DESCRIPTION AND SAFETY ANALYSIS  
OF PROPOSED CHANGE NPF-10/15-150

This is a request to revise Technical Specification 3.2.7, "Power Distribution Limits - Axial Shape Index," for San Onofre Nuclear Generating Station Units 2 and 3.

DESCRIPTION AND SAFETY ANALYSIS  
OF PROPOSED CHANGE NPF-10/15-151

This is a request to revise Figure 3.1-2, "CEA Insertion Limits vs. Fraction of Allowable Thermal Power," of Technical Specification 3.1.3.6, "Reactivity Control Systems - Regulating CEA Insertion Limits," for San Onofre Nuclear Generating Station Units 2 and 3.

Figure 3.1-2  
CEA insertion limits vs fraction  
of allowable thermal power

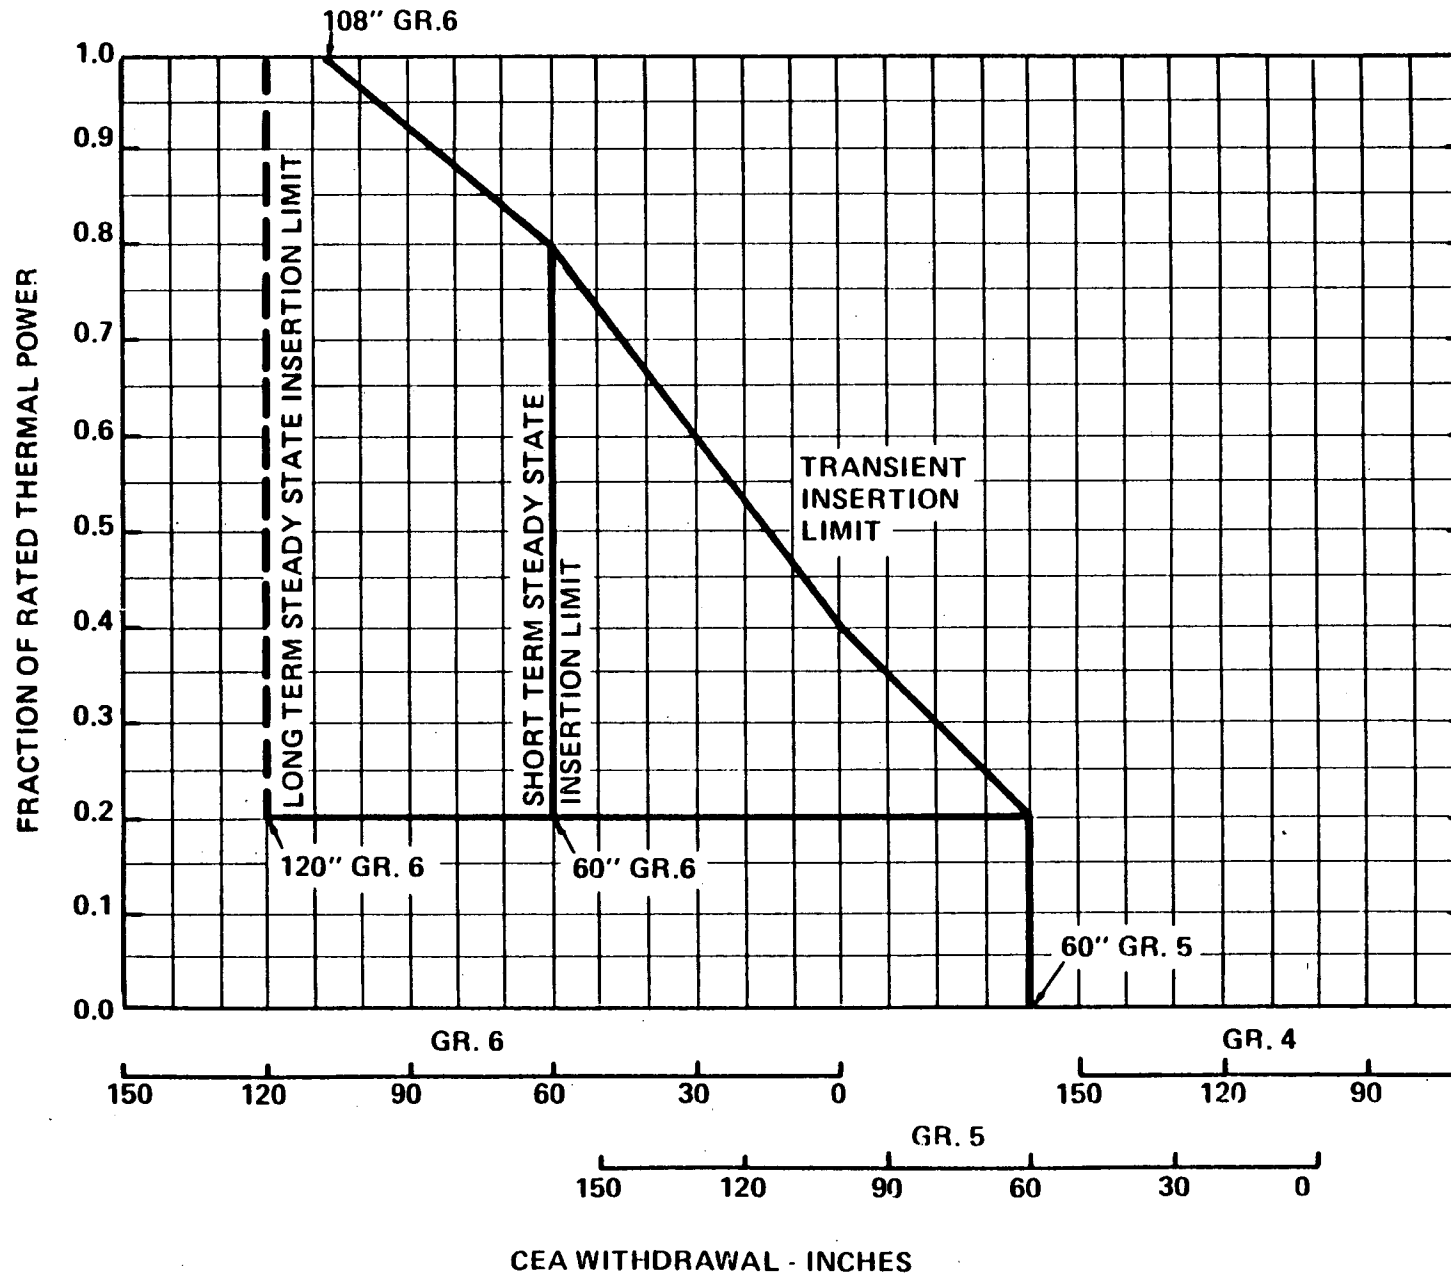
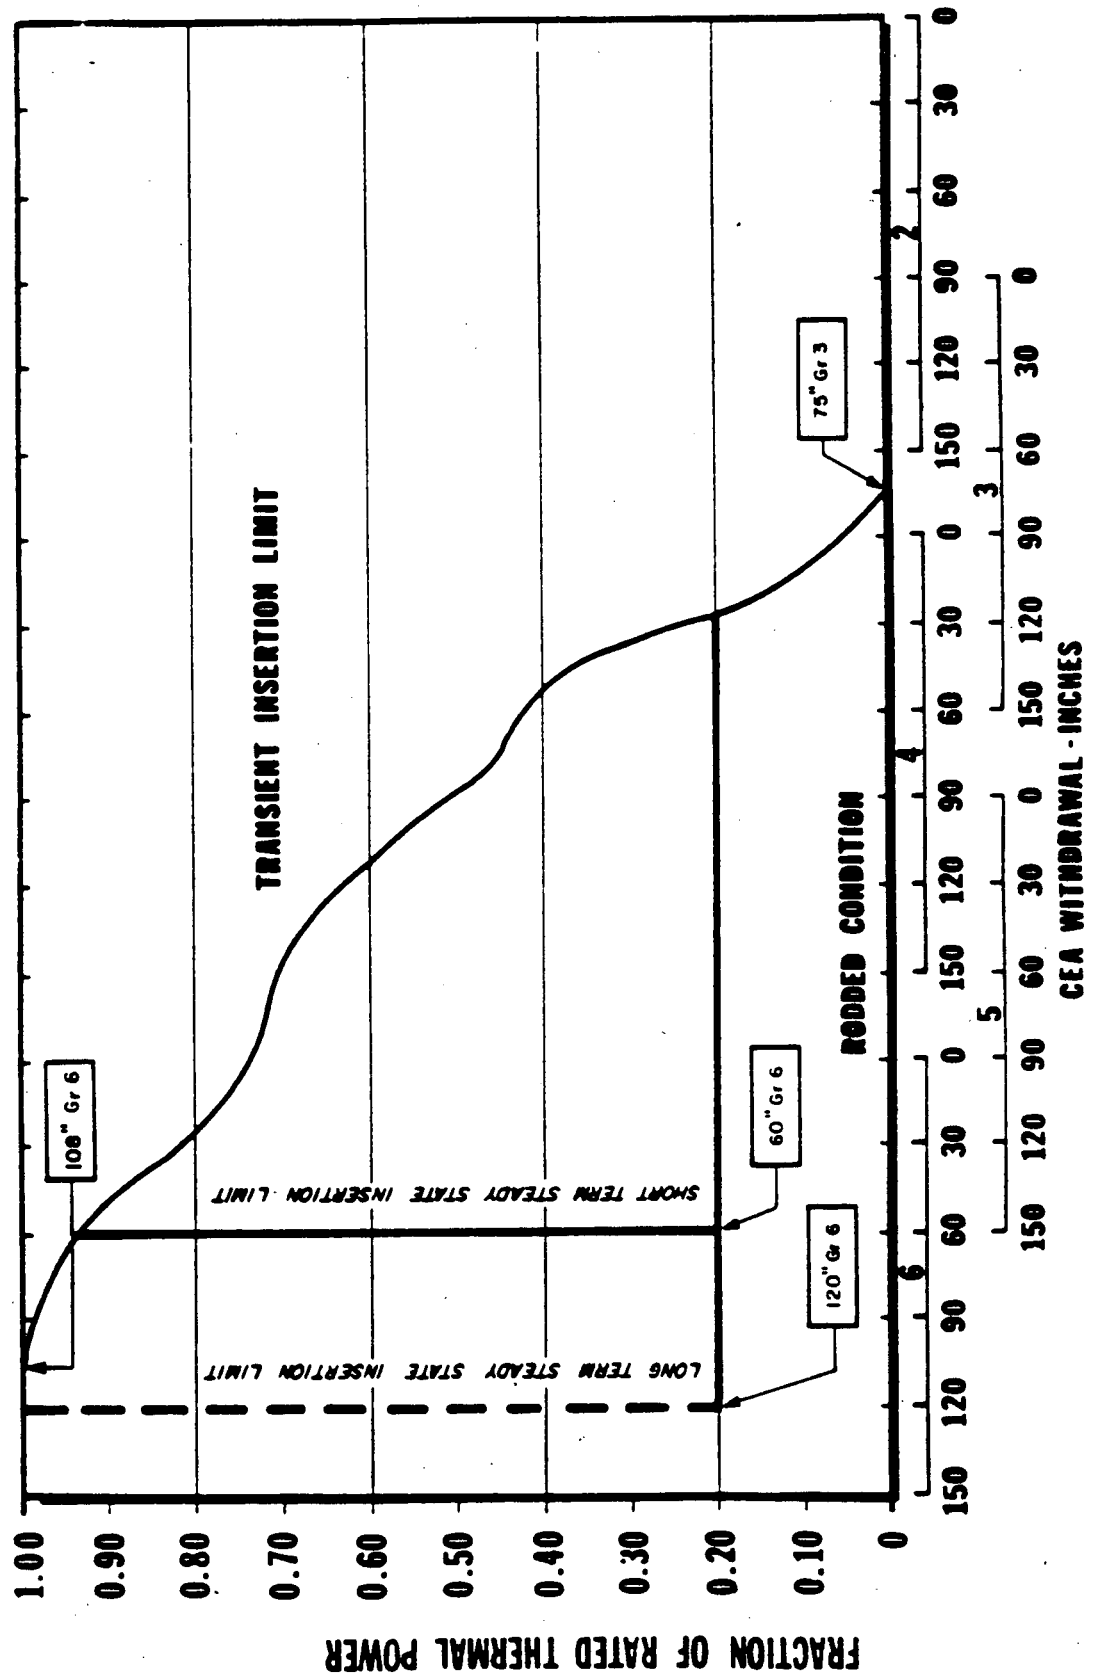
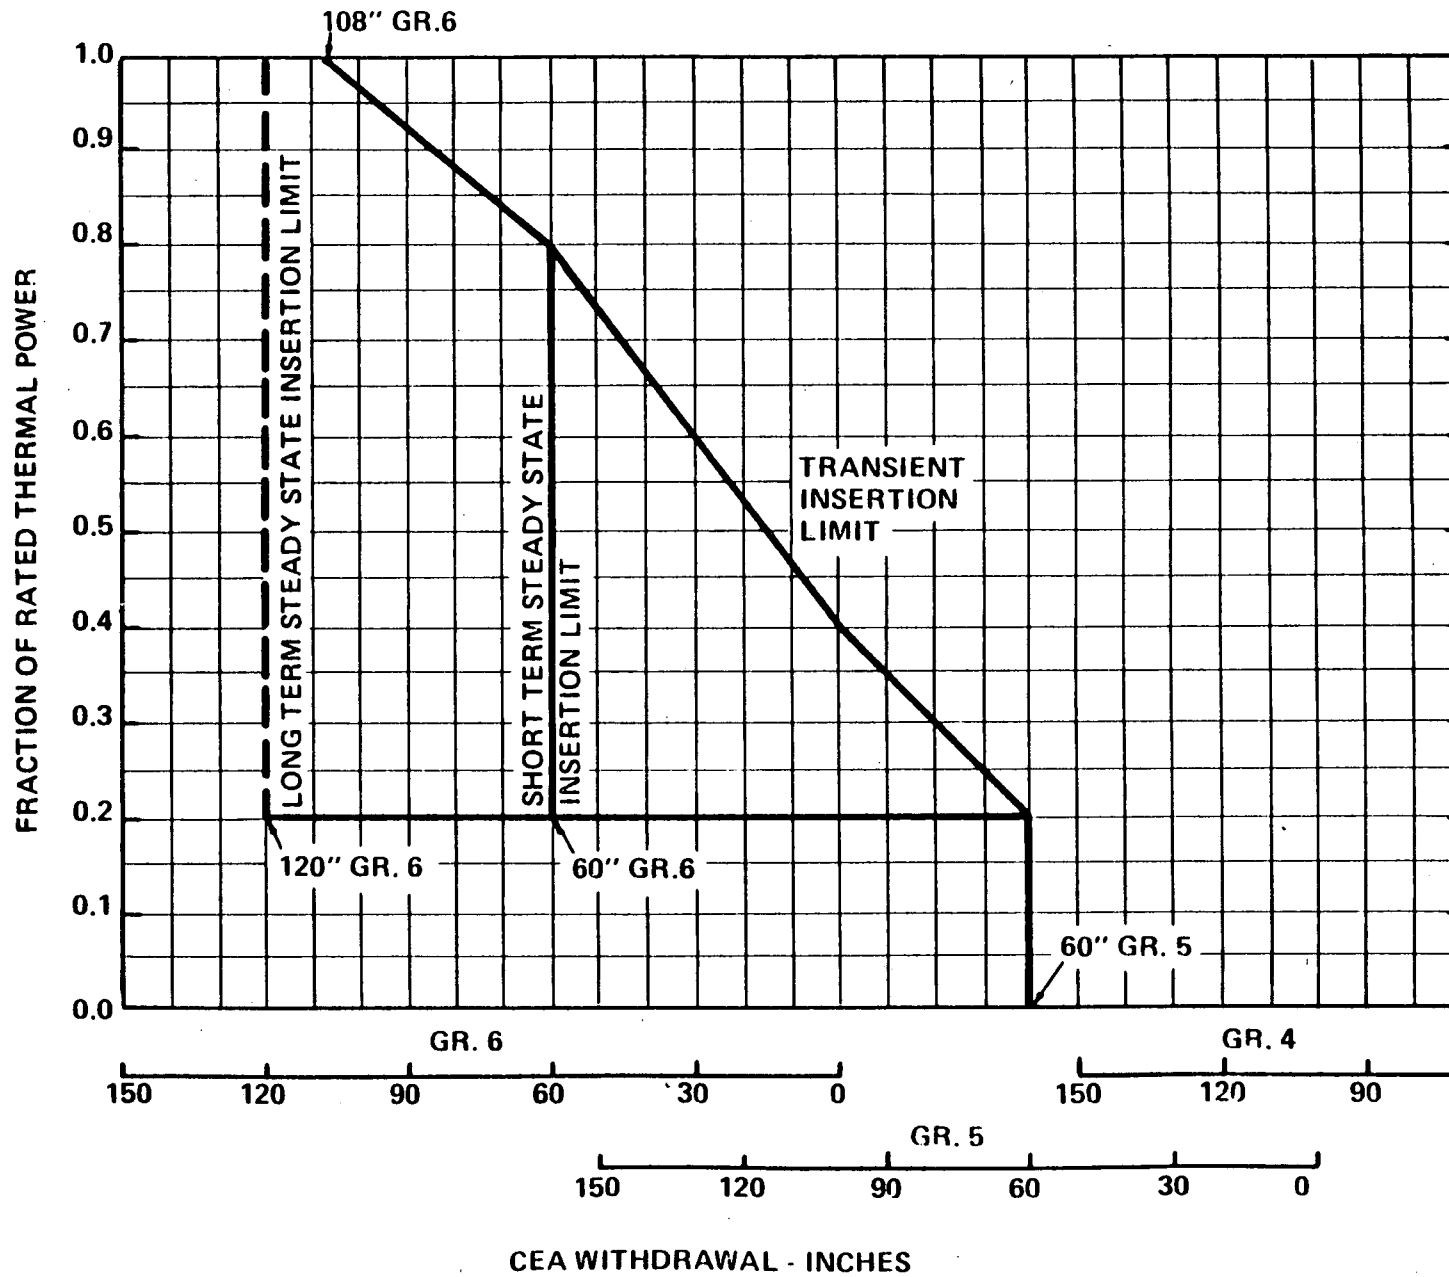
The proposed change will revise Figure 3.1-2, "CEA Insertion Limits vs. Fraction of Allowable Thermal Power," of Technical Specification (TS) 3.1.3.6, "Reactivity Control Systems - Regulating CEA Insertion Limits," which specifies the withdrawal sequence and Power Dependent Insertion Limits (PDIL) for the regulating Control Element Assembly (CEA) groups. The need for a specified withdrawal sequence and PDIL comes from the requirement that reactor design include appropriate margin to assure that specified acceptable fuel design limits are not exceeded during any condition of normal operation, including anticipated operational occurrences. To this end, TS 3.1.3.6 helps to ensure that (1) acceptable power distribution limits are maintained, (2) the minimum SHUTDOWN MARGIN is maintained, and (3) the potential effects of CEA misalignments are limited to acceptable levels.

TS 3.1.3.6 establishes the withdrawal sequence and PDIL. The proposed change will revise the Short Term Steady State Insertion Limit and Transient Insertion Limit specified by Figure 3.1-2. The Long Term Steady State Insertion Limit will remain unchanged. The proposed change to the Short Term Steady State Insertion Limit and Transient Insertion Limit constitutes an additional limitation or restriction which is not included in the existing Technical Specifications, but is included as an assumption in the Cycle 2 accident and transient analysis.

This restriction is imposed in order to reserve more margin for Steam System Piping Failure Inside and Outside Containment. (Standard Review Plan [SRP] Section 15.1.5) and the Spectrum of Rod Ejection Accidents (SRP Section 15.4.8). The results of these two accidents for Cycle 2 are typically more adverse than the results for Cycle 1 due to inherent differences between a first cycle core and reload cores. The safety analysis performed in support of the Cycle 2 reload effort, which includes the two accidents specifically mentioned above, uses assumptions that are consistent with the proposed change.
